Re: 3928 NE Independence Avenue

Notched Header at Master Bath

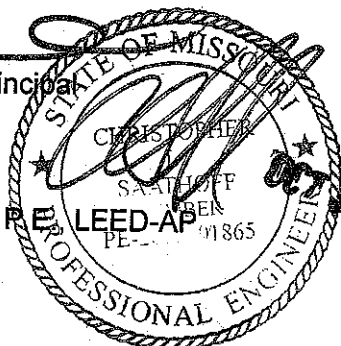
The framer has notched the bottom of the header to allow passage of a plumbing vent. To allow the header to properly transfer load at this location and additional double 2x10 header will need to be placed above the notched header to allow proper transfer of loads at this location.
